# Cal TF

TrickleStar Opposing Technical View Cal TF Meeting: January 28, 2016

#### TRICKLESTAR POSITION

#### FIGURE 26 - HOUSEHOLD'S REPORTING ACTIVE SHUTDOWN'S AND DISLIKE OF CERTAIN FEATURES

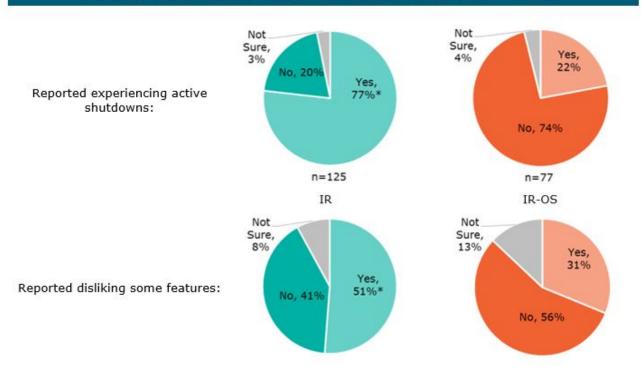
Figure 26 and Figure 27 show differing customer satisfaction measures between the IR and IR-OS models. This could be one of the causes of the higher persistence rate for the IR-OS model, despite the demographic difference mentioned above.

Furthermore, 88 percent of those who experienced having their TV shut down had this happen more than one time, with 41 percent experiencing 6 or more shutdowns. Of the 60% that experienced active shutdown, 83% reported that they have at least once turned the TV back on. This points to the largest source of uncertainty in using the simulated M&V approach which may not account for users turning equipment back on after active shutdown.

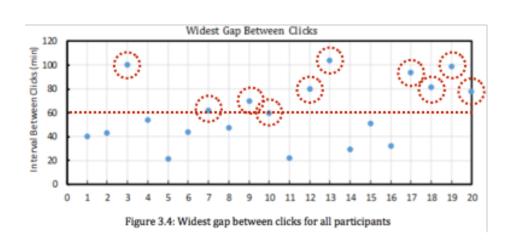
Furthermore, we believe that the PG&E report authors and the San Diego Gas & Electric (SDG&E) work paper development team assume that the flashing LED warning light on the SVS testing equipment was sufficient to ensure appropriate user engagement in the Phase One field test.

In other words, they assume that this flashing LED light was sufficient to avoid active shutdown events.

How can this be the case, when 77% of the homes using the IR-only Tier 2 APS device in the qualitative study experienced active shutdowns with the <u>exact same flashing</u> LED light in operation?
